INDEPENDENT ORBITER ASSESSMENT

**FMEA/CIL
ASSESSMENT
FINAL REPORT**

WORKING PAPER NO. 1.0-WP-VA88003-47

INDEPENDENT ORBITER ASSESSMENT
FMEA/CIL ASSESSMENT FINAL REPORT

Figure C.3 - D&C FMEA/CIL ASSESSMENT

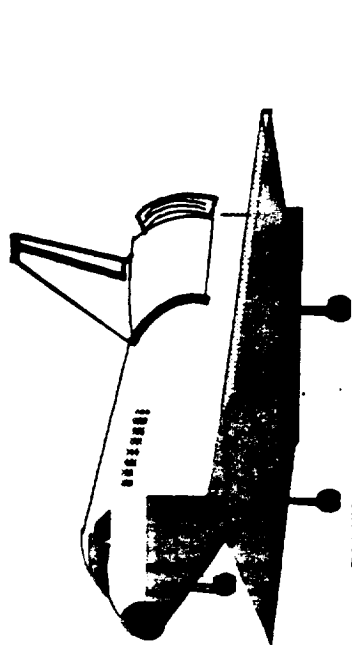
The issues arose due to different interpretation of NSTS 22206, the FMEA and CIL preparation instructions. IOA analyzed the electrical circuits as black boxes, and NASA analyzed the components within the black boxes. Of the 45 differences with the FMEAs, all were minor and did not affect criticality assessments. In conclusion, IOA is in full agreement with the revised NASA CIL baseline.

Figure C.4 - GNC FMEA/CIL ASSESSMENT

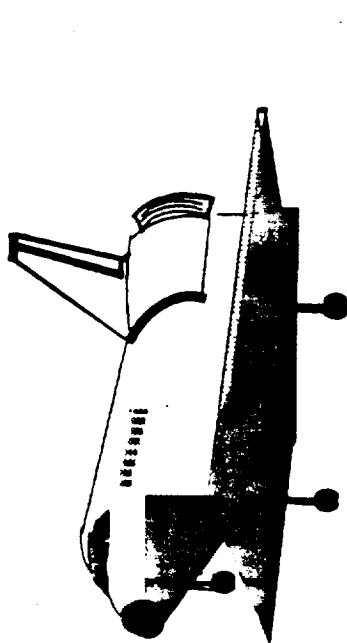
The IOA product for the Guidance, Navigation and Control (GNC) analysis consisted of 141 failure mode worksheets that resulted in 24 PCIs being identified. In order to facilitate comparison, 34 additional failure mode worksheets were generated. Comparison was made to the NASA baseline (as of 4 January 1988) which consisted of 148 FMEAs and 36 CIL items. The comparison determined if there were any results which had been found by the IOA that were not in the NASA baseline. This comparison produced agreement on all but 56 FMEAs, with no differences in CIL items (reference Figure C.4).

The issues arose due to different interpretation of NSTS 22206, the FMEA and CIL preparation instructions. IOA analyzed the components of the electrical circuits, generating 56 worksheets more than NASA, who treated the electrical circuits as black boxes. Of these 56 differences with the FMEAs, all were minor and did not affect criticality assessments. Three of the FMEA issues were with the Solid Rocket Booster Rate Gyro Assembly EPD&C. No drawings were available to assess these FMEAs. In conclusion, IOA is in full agreement with the revised NASA CIL baseline.

Figure C.12a - ATCS FMEA/CIL ASSESSMENT

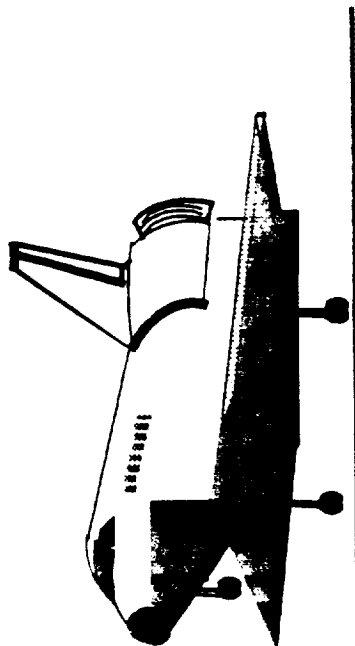
In conclusion, all ATCS CIL issues have been resolved as shown in Figure C.12a.

Figure C.16 - ARPCS FMEA/CIL ASSESSMENT

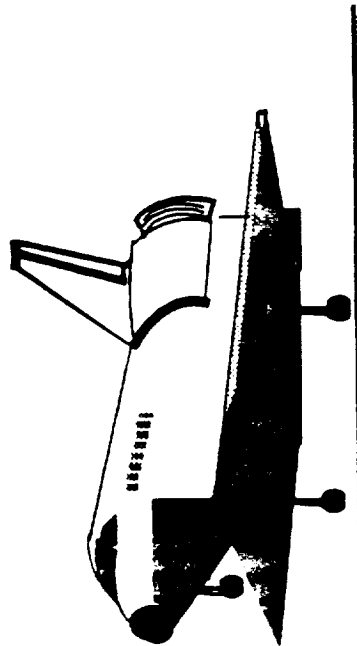
Re-evaluation by NASA of the EPD&C failures resulted in revised criticalities for four of the CIL issues. These revised criticalities matched IOA's recommendations and the issues were closed.

IOA's original analysis was completed before the decision to remove the auxiliary O2 tank was made. The knowledge of this design change led to a re-evaluation of IOA's assigned criticalities and withdrawal of a second group of issues.

In summary, all CIL issues have been resolved. Figure C.16 presents the final resolution of the ARPCS assessment.

Figure C.19 - MMU FMEA/CIL ASSESSMENT

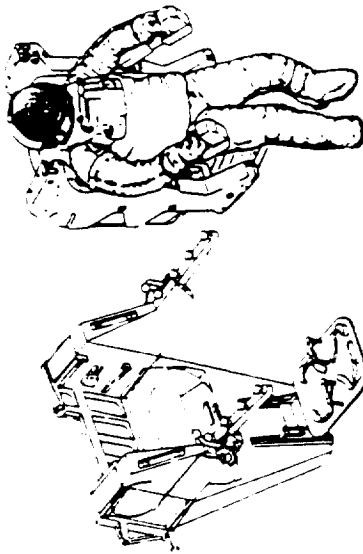
The IOA analysis of the Manned Maneuvering Unit (MMU) hardware initially generated 136 failure mode worksheets and identified 69 PCIs before starting the assessment process. In order to facilitate comparison, 57 additional failure mode analysis worksheets were generated. These analysis results were compared to the proposed Martin Marietta Post 51-L baseline of 179 FMEAs and 110 CIL items. Upon completion of the assessment, 121 of the 204 IOA failure modes remained as issues to be resolved. A summary of the FMEA/CIL counts for IOA and NASA is provided in Figure C.19, and some of the significant issues follow.

The MMU Prep and Post-Ops definitions were not too clear, and it was consequently difficult to match their criticalities. IOA considered every MMU activity to begin with Pre-Ops activities and end with Post-Ops activities prior to the start of the next MMU operations. The Martin Marietta definition seems to suggest that the Prep activities start with the first MMU Pre-Ops and stop after the last MMU Ops activity. The period after the last planned MMU Ops will then be Post-Ops.

Figure C.20 - NWS FMEA/CIL ASSESSMENT

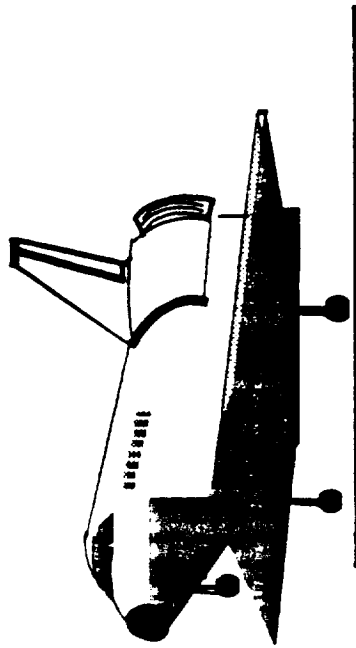
The IOA analysis of the Nose Wheel Steering (NWS) hardware initially generated 78 failure mode worksheets and identified 42 Potential Critical Items (PCIs). As a result of the assessment process, 15 NWS failure mode worksheets were deleted and an additional 5 analysis worksheets were generated and added to the assessment package. The assessment comparison also gave rise to 14 issues between the IOA NWS analysis and the corresponding NASA FMEAs (Fig. C.20).

Figure C.22 - ARS FMEA/CIL ASSESSMENT

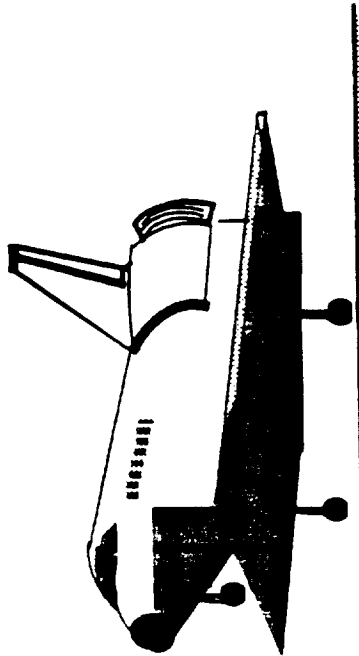
In summary, all ARS CIL issues have been resolved. Figure C.22 shows the final resolution of the ARS assessment.

Figure C.28 - COMM & TRACKING FMEA/CIL ASSESSMENT

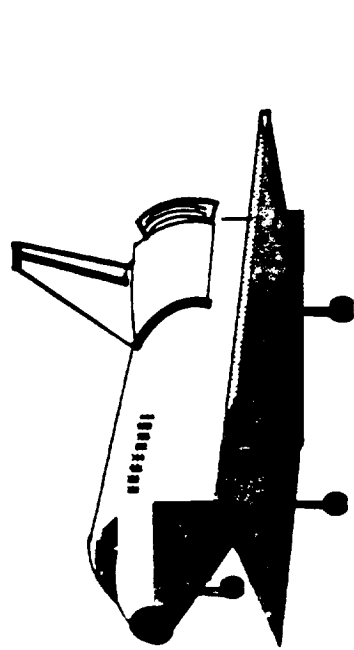
Rationale for resolution of each CIL issue appears under the "remarks" section on the applicable assessment work sheets contained in the companion volume to this report, the CIL Issues Resolution Report. Figure C.28 provides a numerical overview of the C&T FMEA/CIL assessment.
